Moser Pass At Denali Final Development Plan

REQUEST: The applicant is seeking approval of final development plan and final plat by demonstrating compliance with all conditions of approval that are specifically required. This submittal specifically addresses the incompleteness items included in the October 24, 2023, incompleteness letter.

II. INCOMPLETENESS LETTER ITEMS

01 AREA MAP

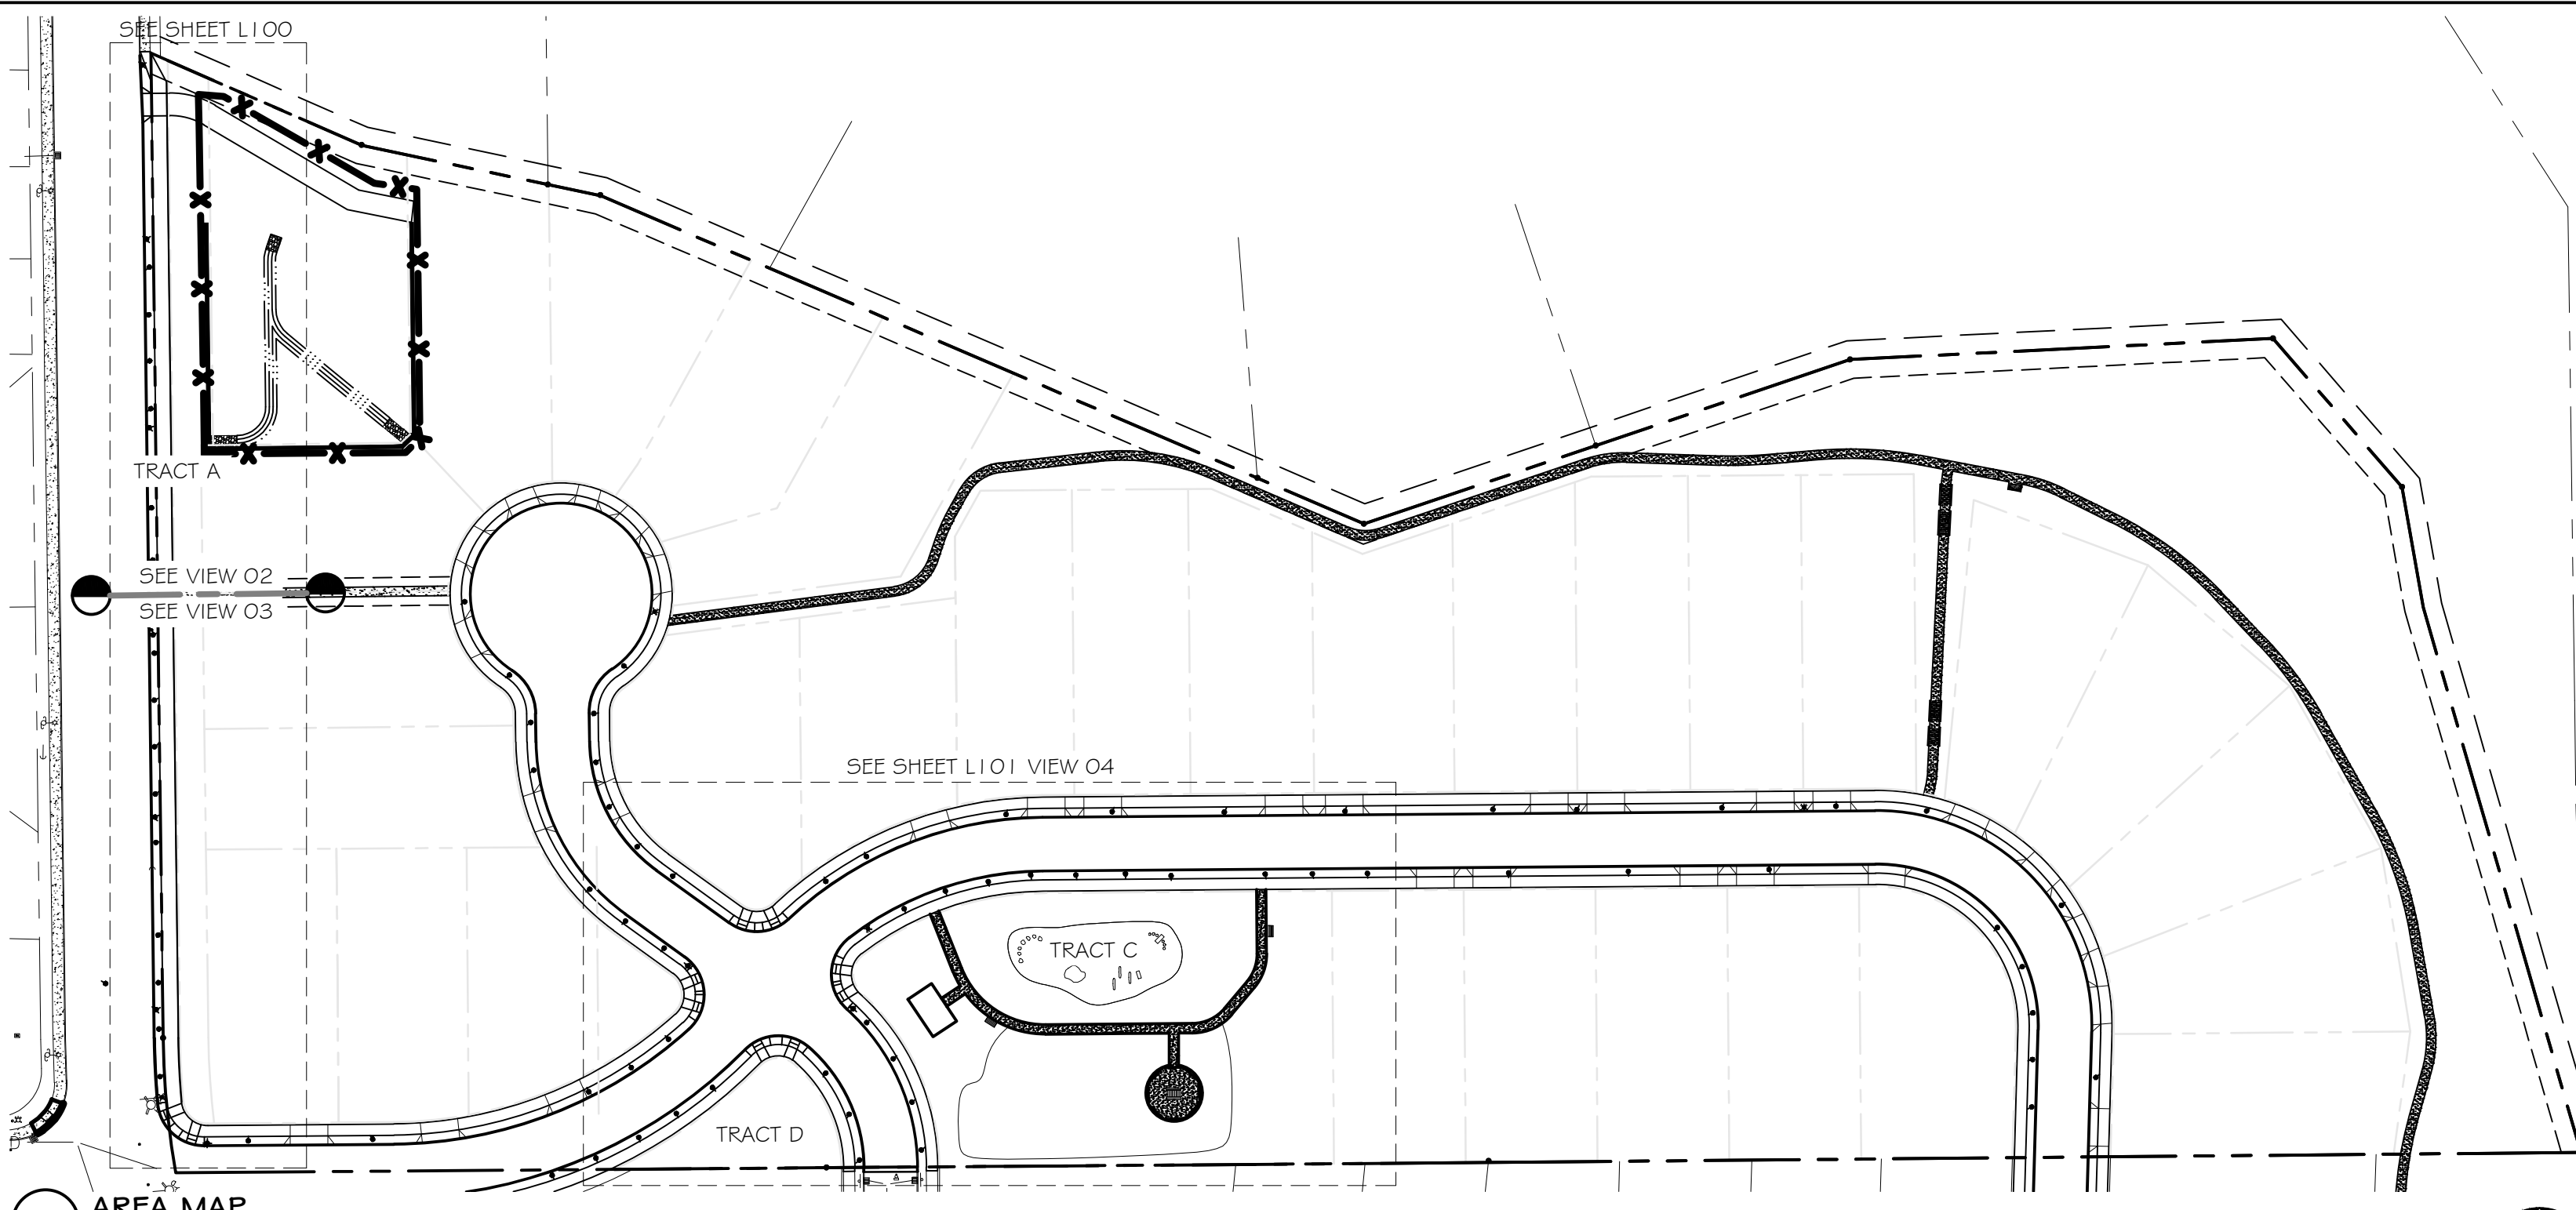
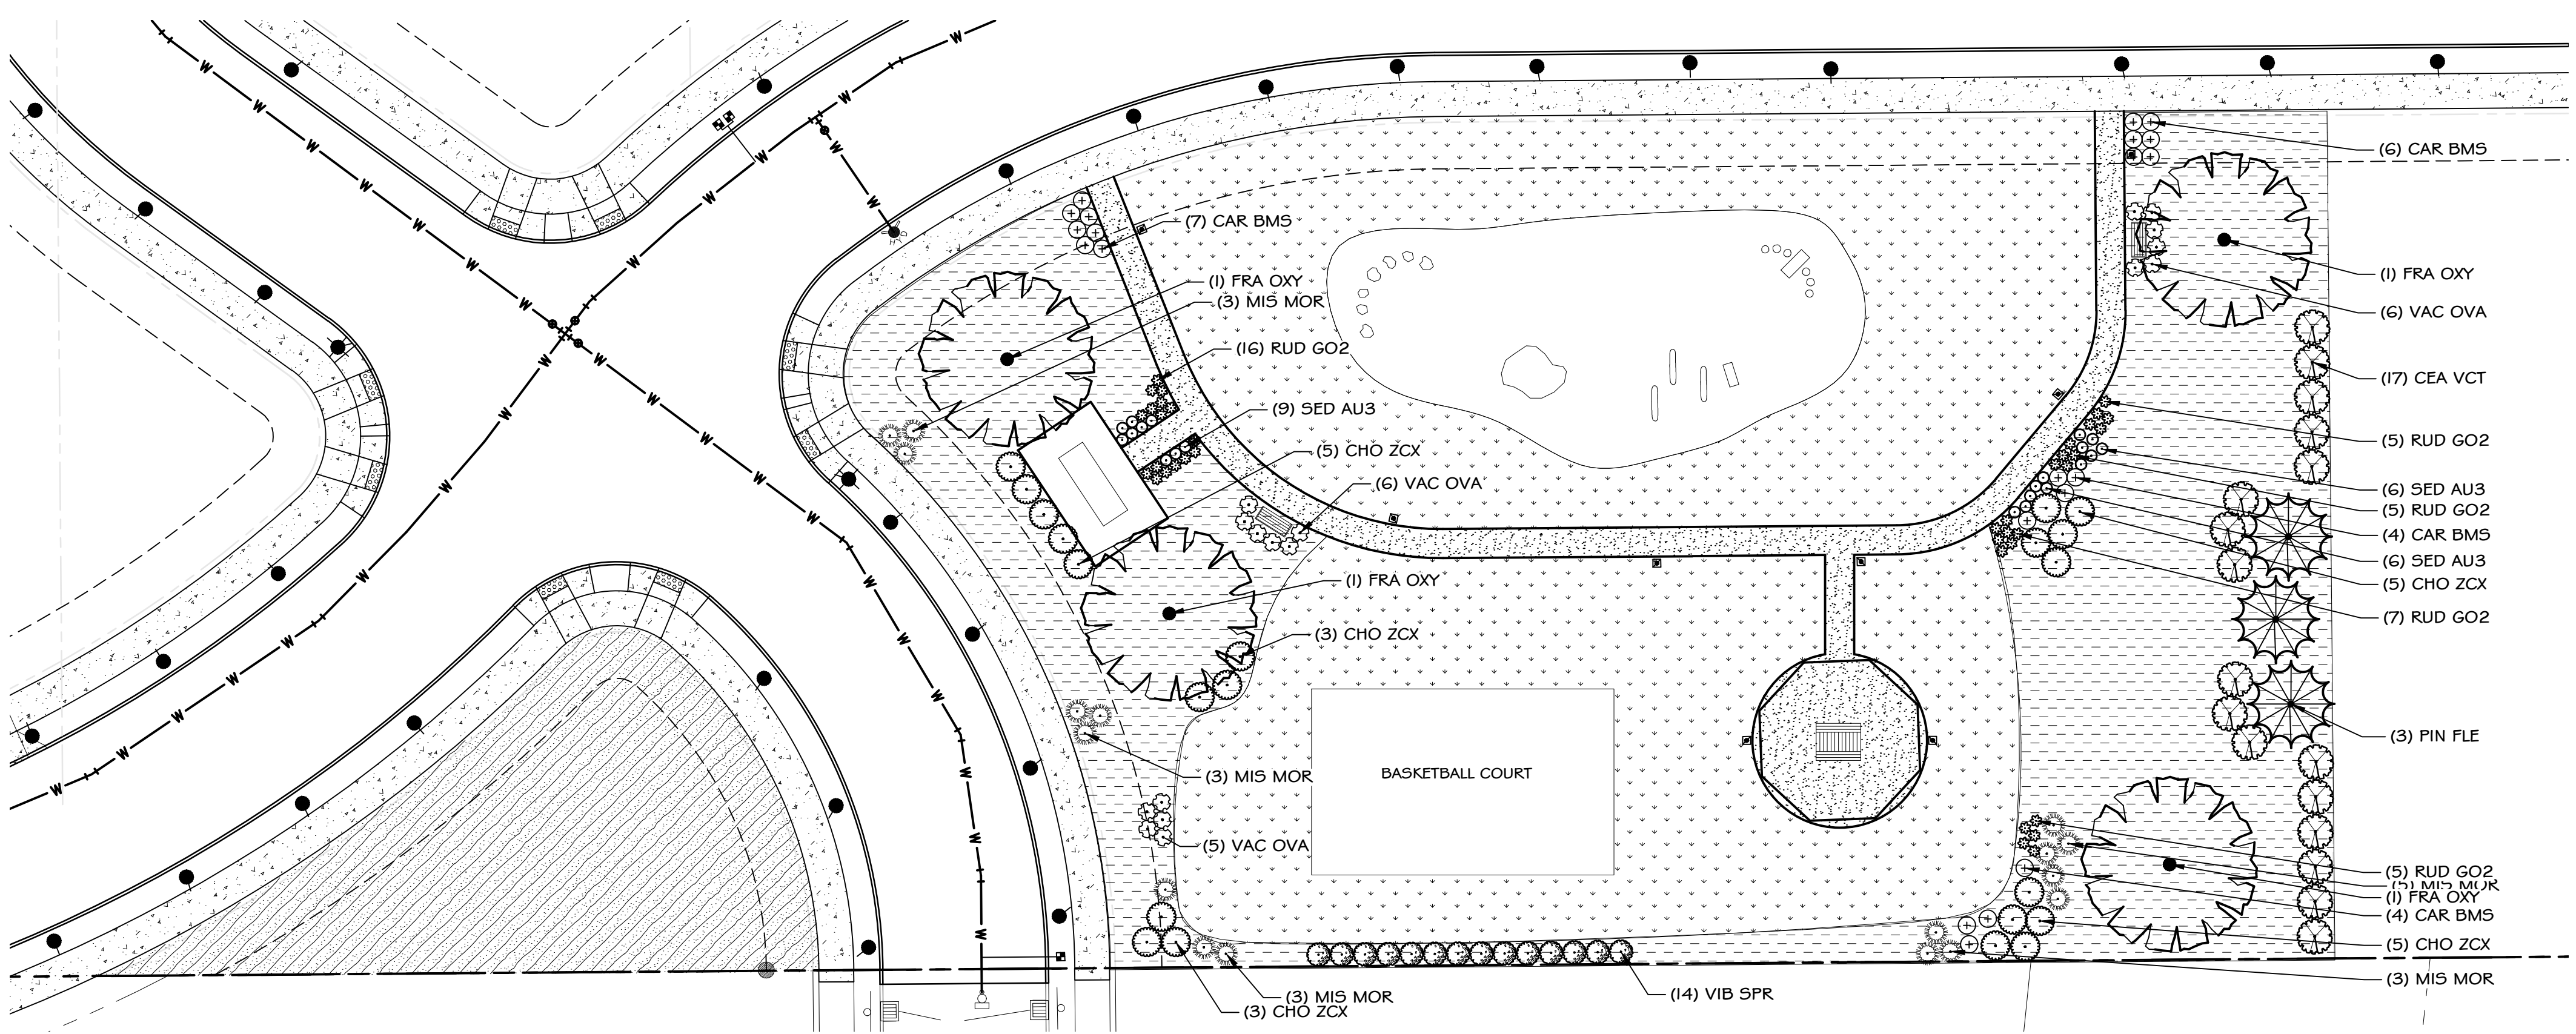
5. Prior to Final Development Plan approval, provide a final Landscape Plan (including open space improvements) and Forest Restoration Plan.

The Landscape and the Forest Restoration Plans must be certified by a licensed landscape architect and a Certified Arborist. Please provide their certification stamps.

Applicant Response: The applicant has included the updated Landscape Plan with appropriate certification information by the required professional. Also included in this submittal is a memo by the project Arborist certifying the Forest Restoration Plan.
